Urgent: Field Safety Notice

Fisher & Paykel Healthcare (F&P) Airvo™ 3

F&P Reference: FA-2024-003

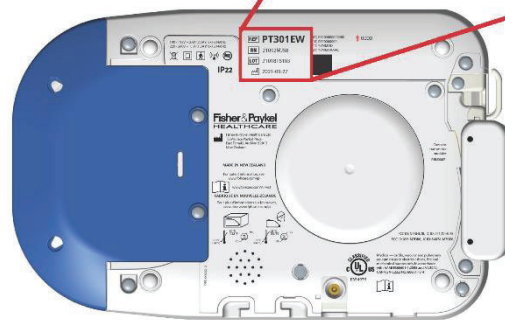
This field safety corrective action relates to specific versions of software of the Airvo 3, and how the device responds when flow alignment alarm 3.2.2 occurs.

When this happens in Airvo 3 devices set up with High Pressure Oxygen (HPO) and running software version 1.5.1 or earlier, the device will deliver room air only. If this happens, a patient may experience oxygen desaturation that could lead to hypoxia.

Software version 1.5.2 updates the software algorithm and ensures the target therapy continues in the event that this alarm occurs.
